AGENDA

La Vergne Planning Commission
January 27, 2026 at 6:00 PM

Planning Commission Report
Meeting: January 27, 2026

PROJECT NUMBER 20250029
DRAWING NUMBER C1.0

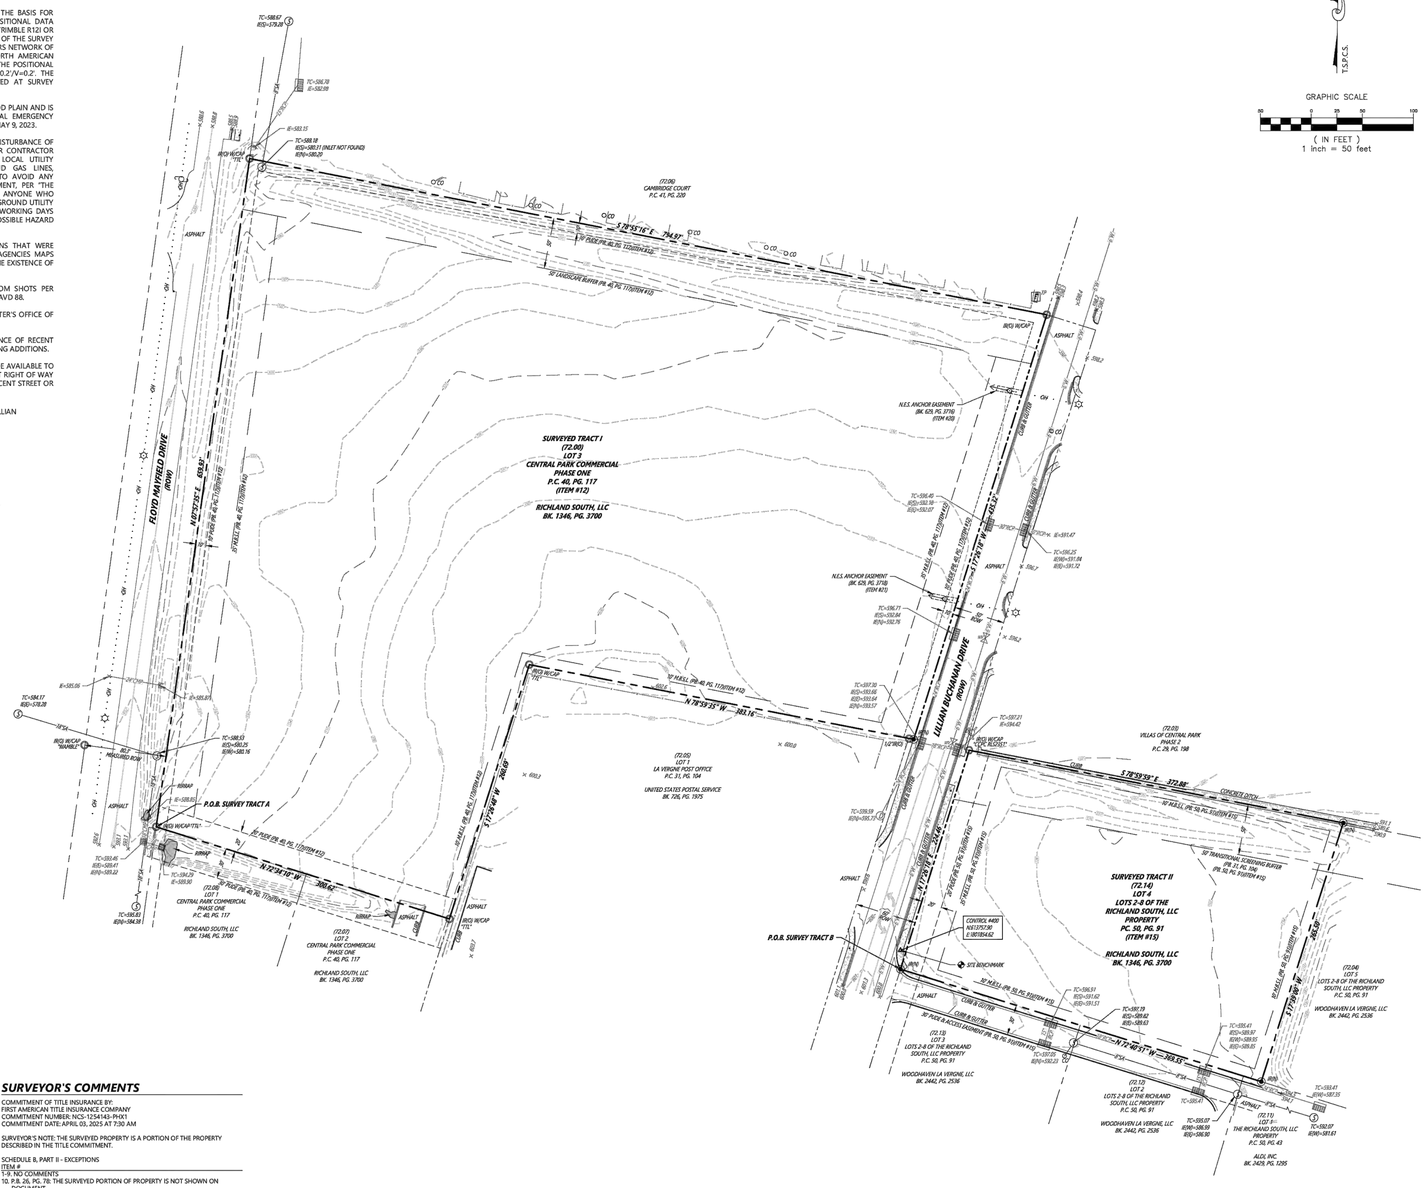
5. (Sheet C1.0) Add a finished floor elevation (FFE) for the existing condo unit closest to Floyd Mayfield drive and just north of the northwest property corner.

15. (Sheet C1.0) Show the existing fire hydrant at the northwest corner of the property.
16. (Sheet C2.0) Add the city general notes shown as G03 within the Permitting and Construction General Information and Requirements document found at the following link: https://www.lavergnetn.gov/DocumentCenter/View/4671/Permitting-and-Construction-General-Information-and-Requirements

DRAWING NUMBER
C5.0

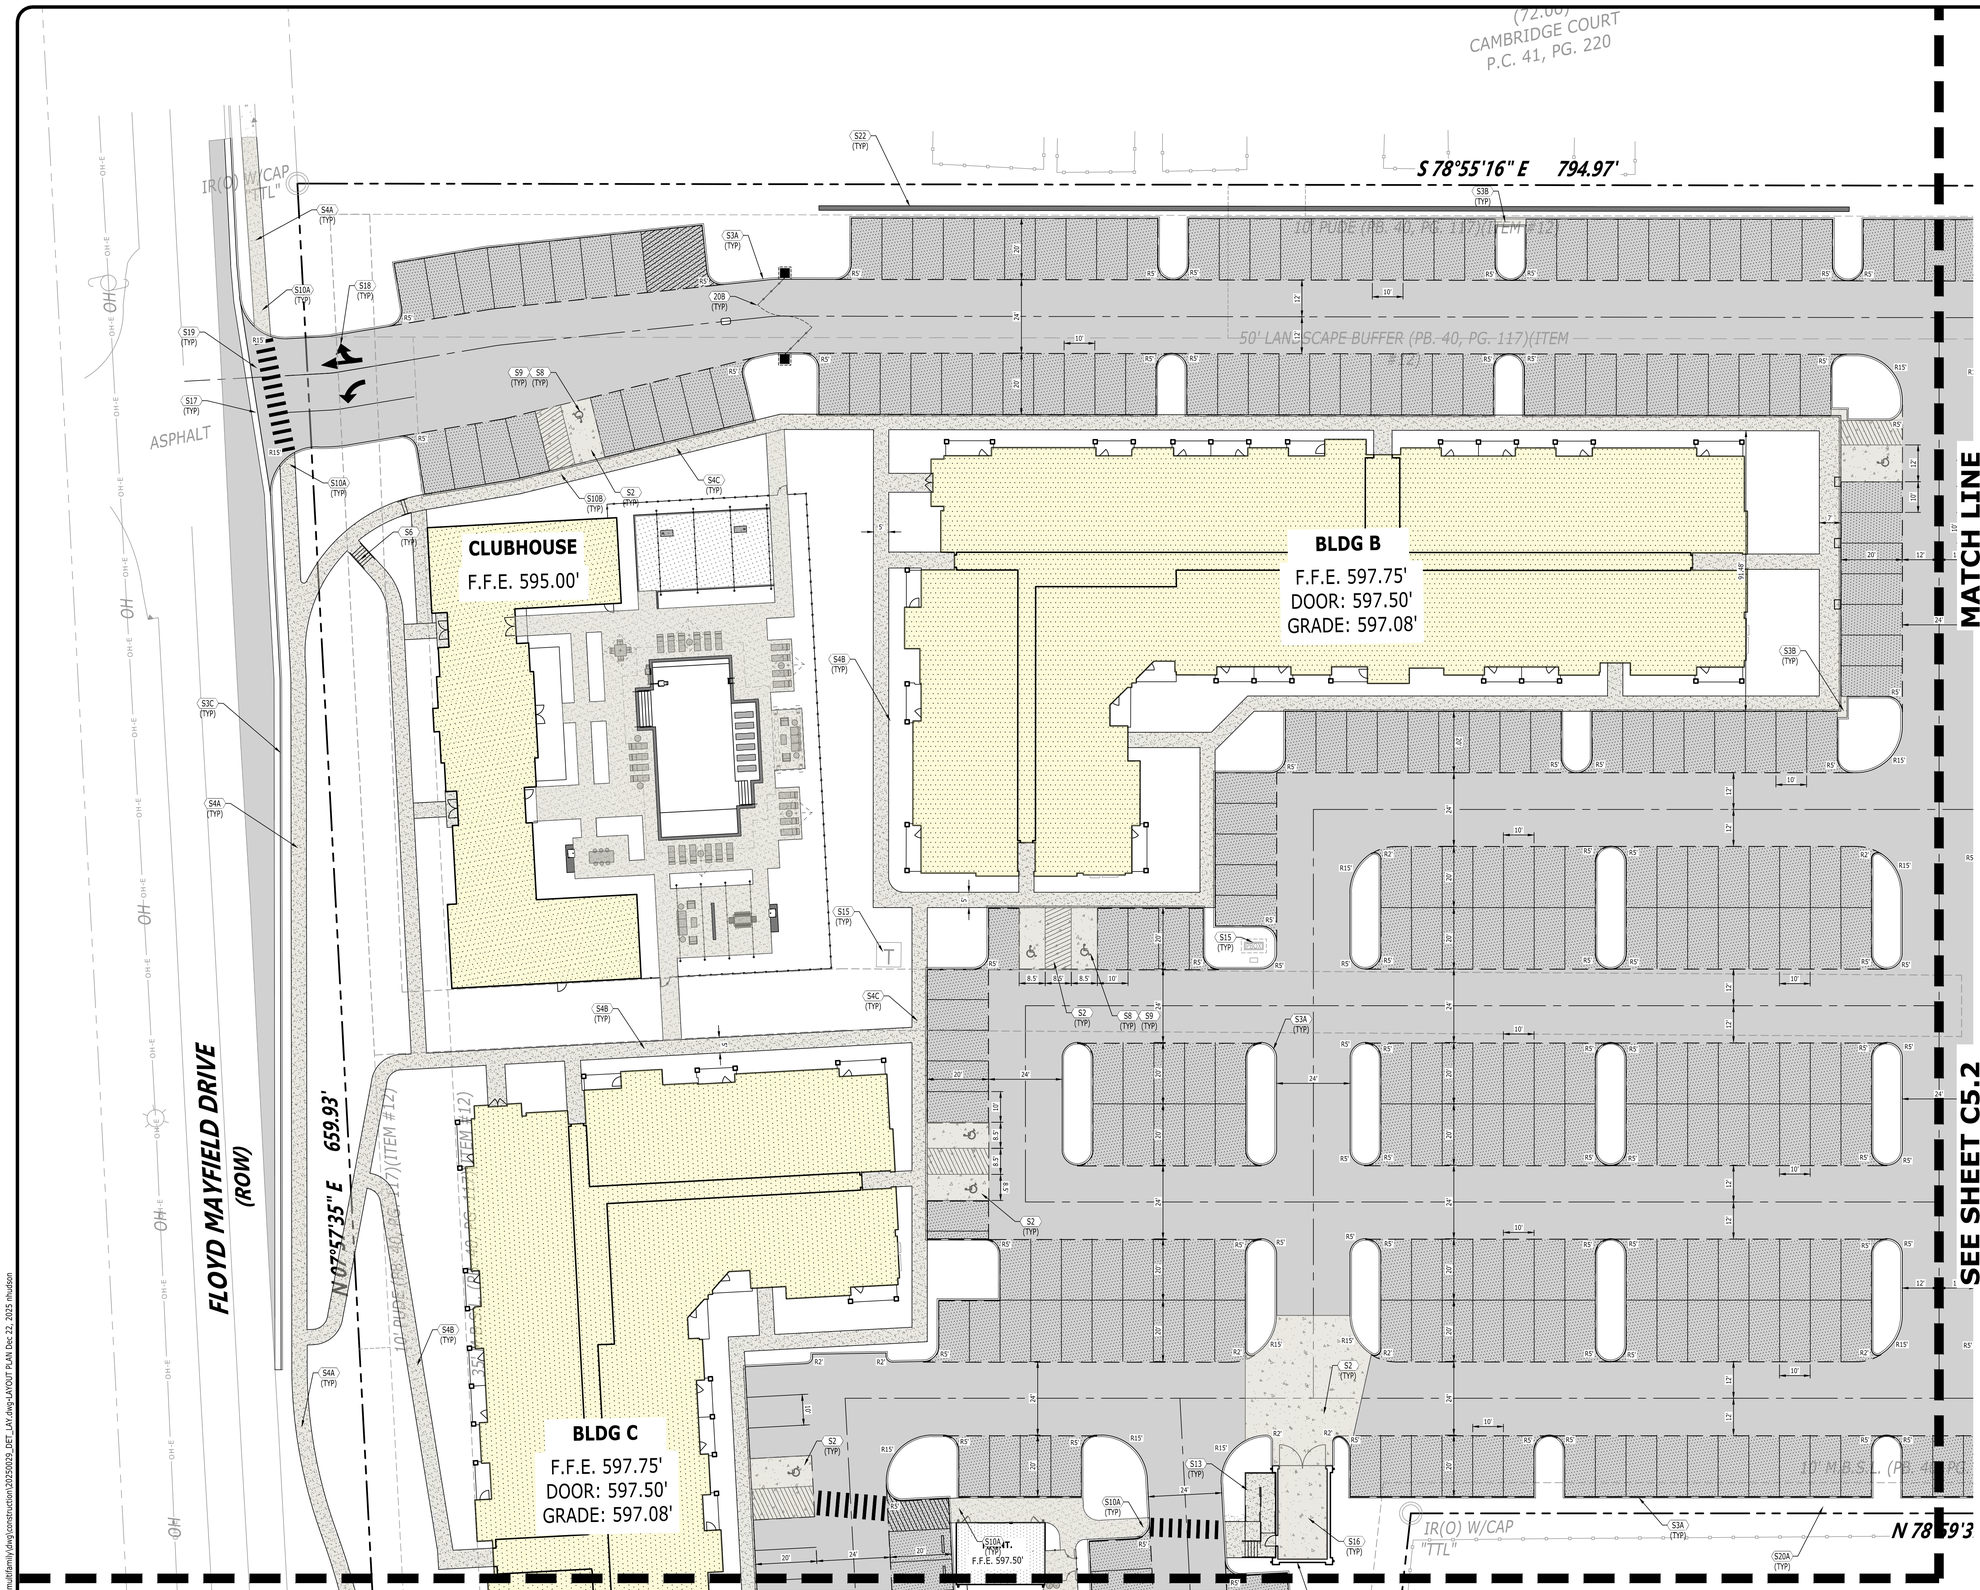
26. (Sheet C5.0) Show the proposed and allowed ISP in the Site Data.

DRAWING NUMBER
C5.1

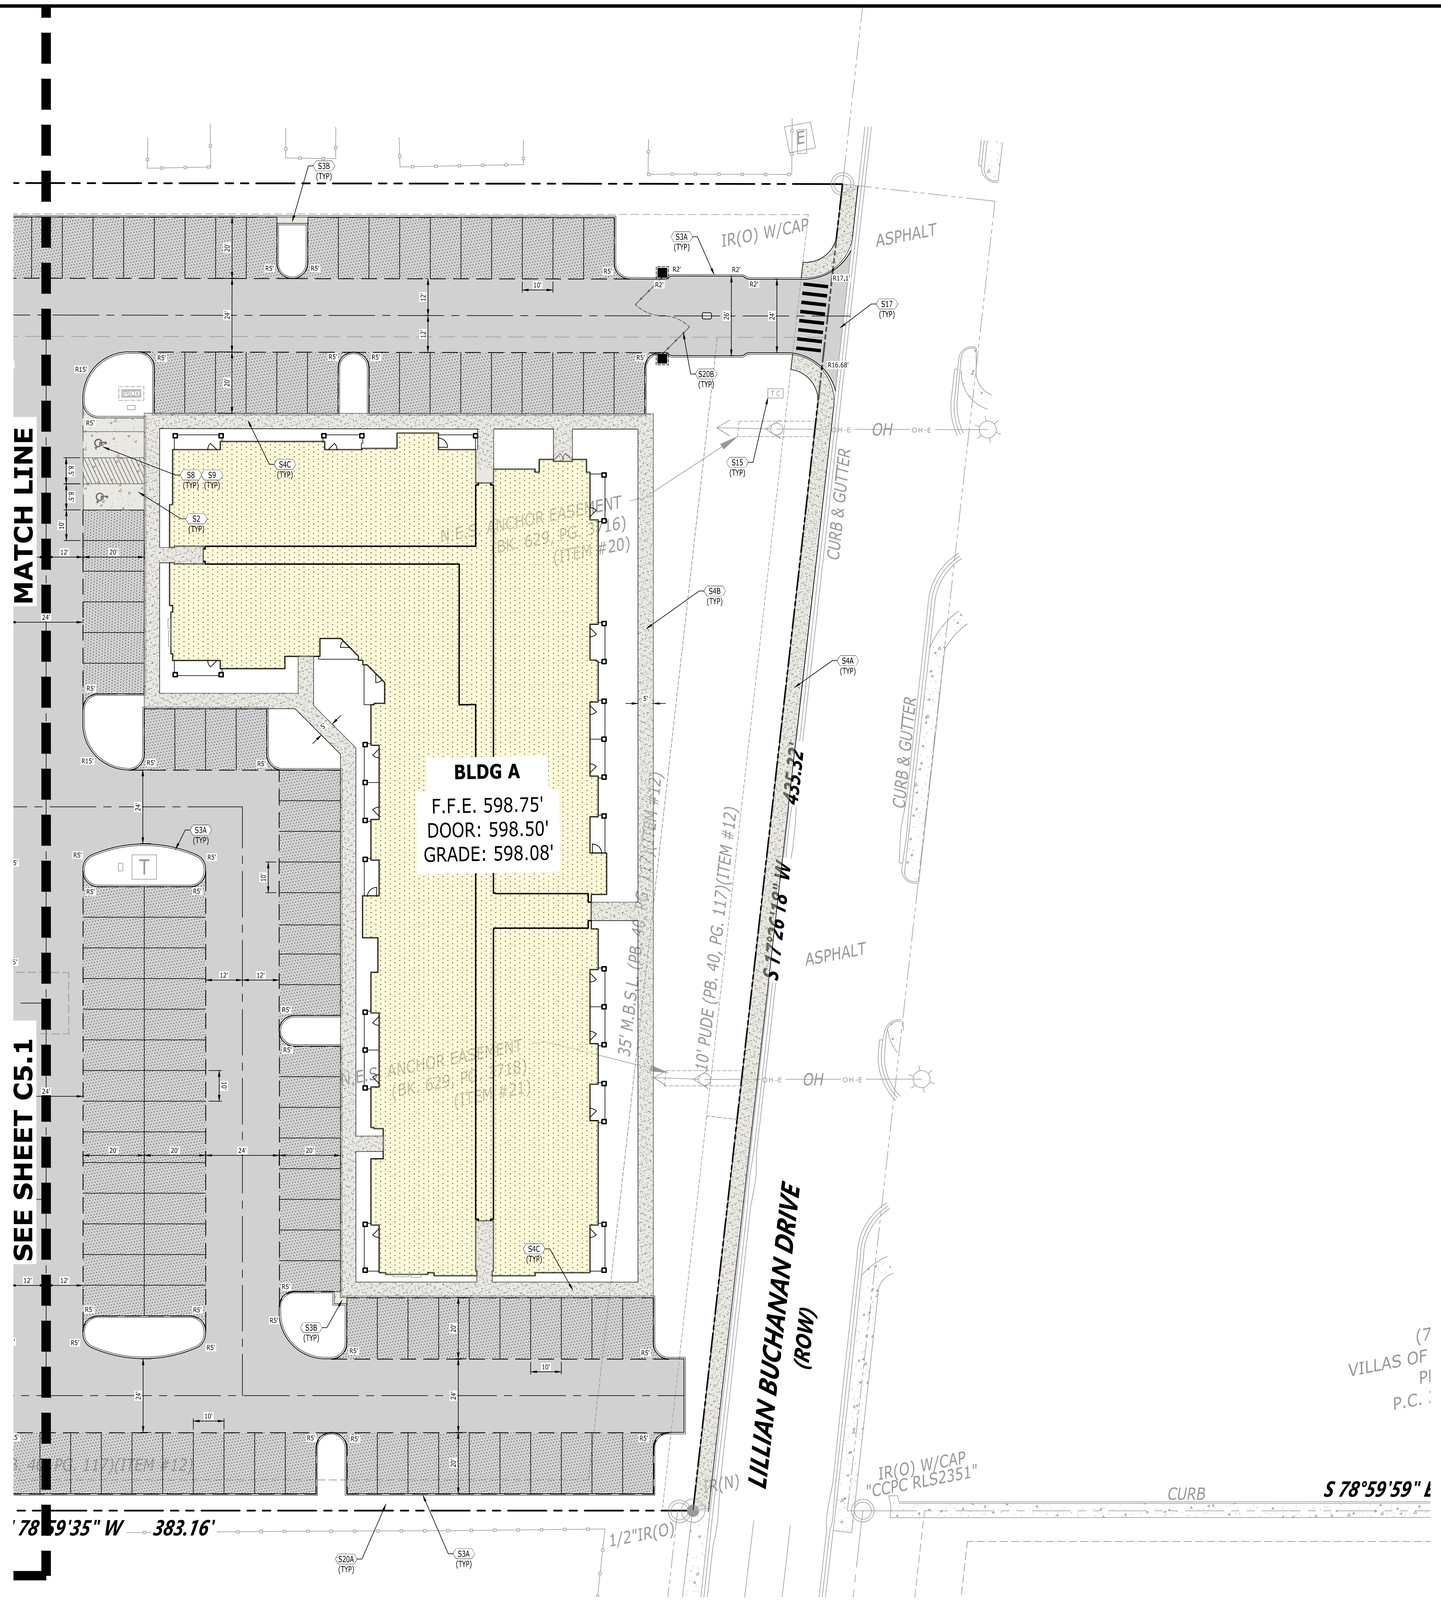
11. (Sheet C8.4) Remove references to the Inspection Ports being optional. They are required and their use should be incorporated into the LTMP.
12. (Sheets C5.1 through C5.3) Provide sufficient information to field locate each building on the site. This can be two building corners or one building corner with a bearing.

18. (Sheet C5.1, C5.2, and C5.3) Show lane widths for driveways.
19. (Sheets C5.2, C5.3, and LSP1.0) On sheets C5.2 and C5.3, notes for S20A and S20B say to “See Landscape Plans). Provide heights, materials, locations, and details for the fencing and gates as referenced. “Decorative Fencing” is insufficient for description.

20. (Sheets C5.1, C5.2, and C5.3) Show distances from edge of driveways to nearest property line.
21. (Sheets C5.1, C5.2, and C5.3) Show distances from back of curb in parking areas to nearest property line.

22. (Sheets C5.1, C5.2, and C5.3) Show dimensions for all traffic islands and curb extensions.
23. (Sheet C5.1) Show dimensions for concrete paving in front of compactor.

DRAWING NUMBER
C5.3

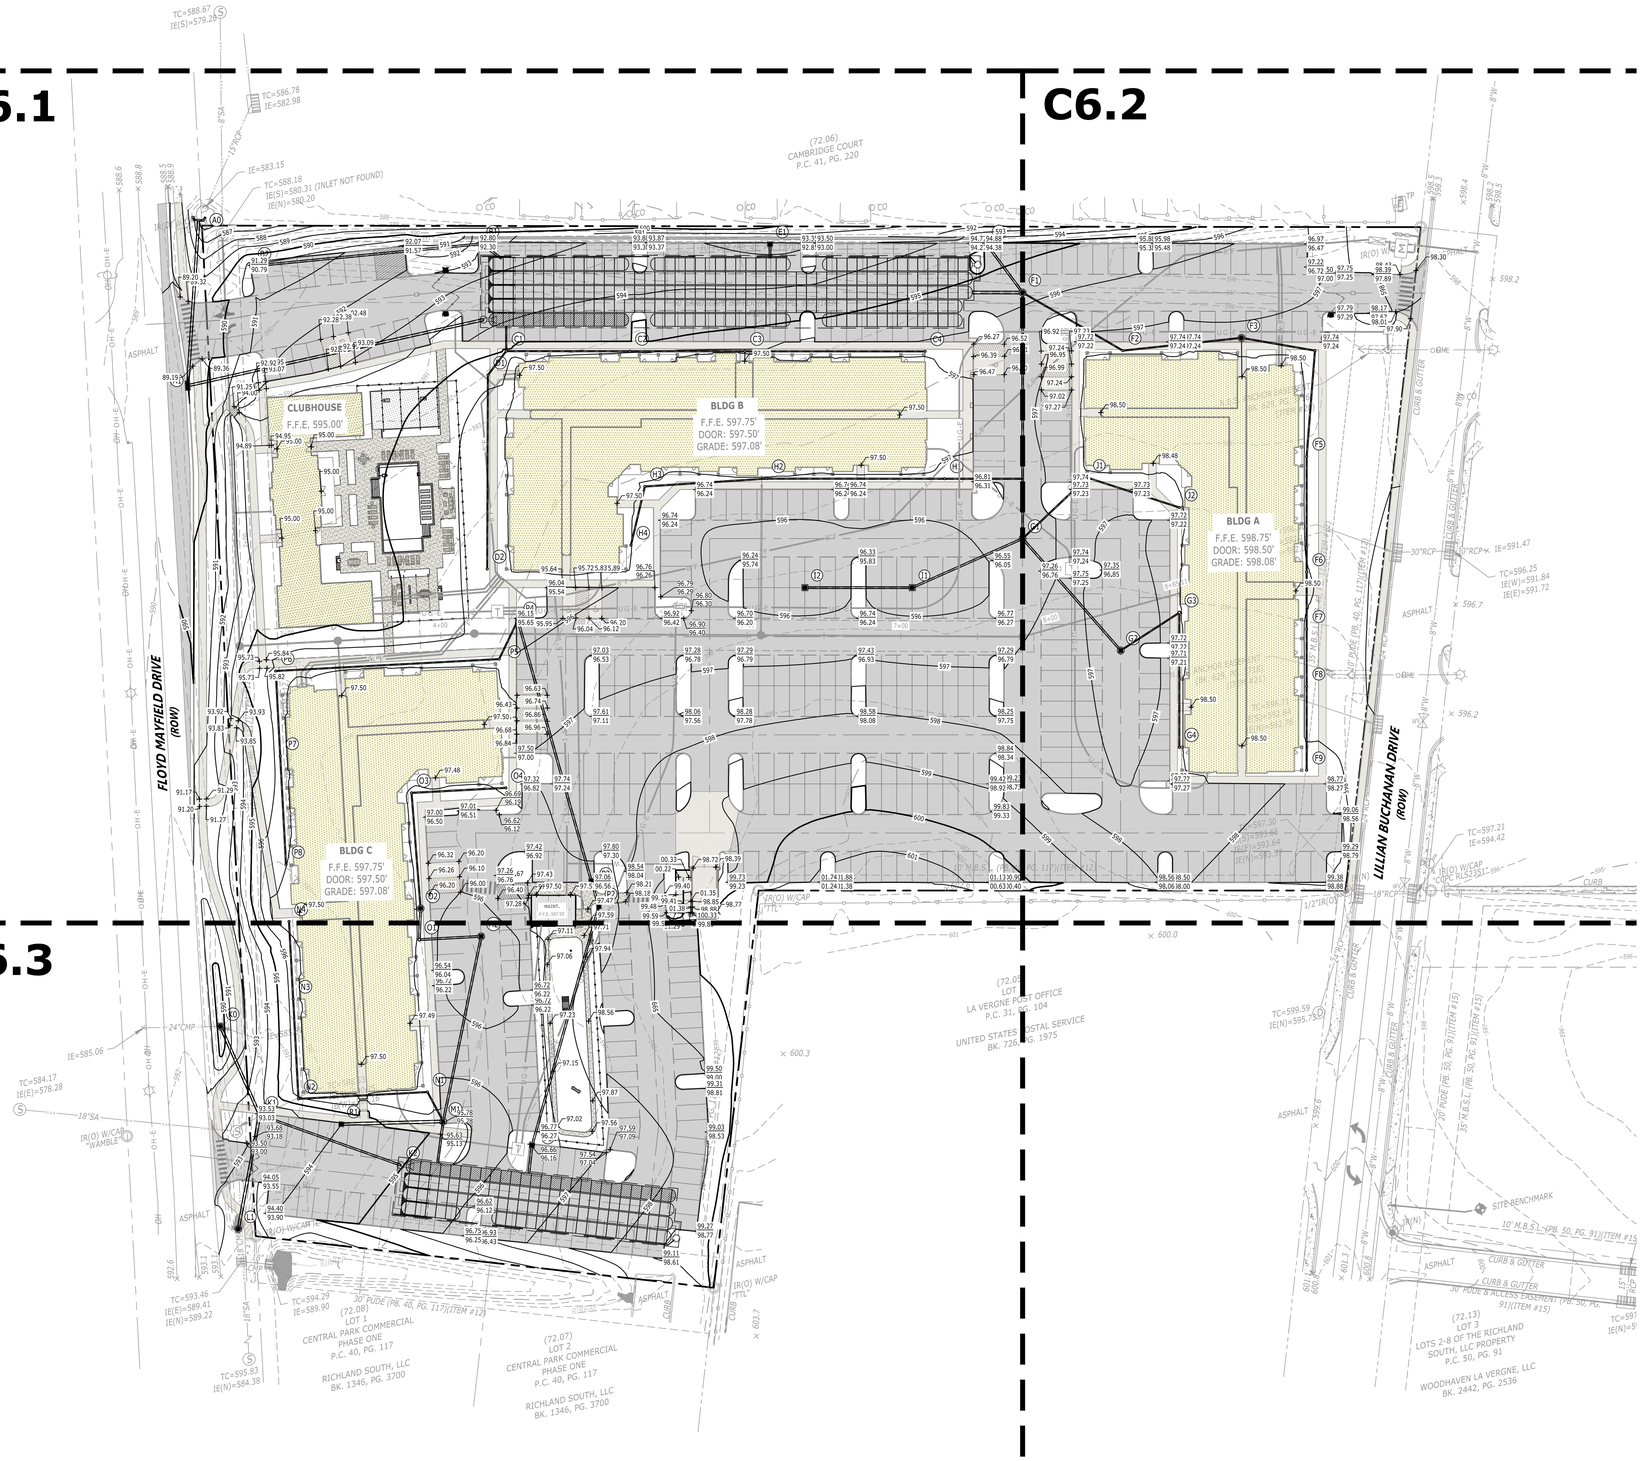
24. (For Information Only) (Sheet C6.1) Since retaining wall is less than four feet high, no detailed structural drawings are required.
25. (Sheet C5.3 and LSP1.0) Label and show dimensions for the open area that appears to be a dog park.
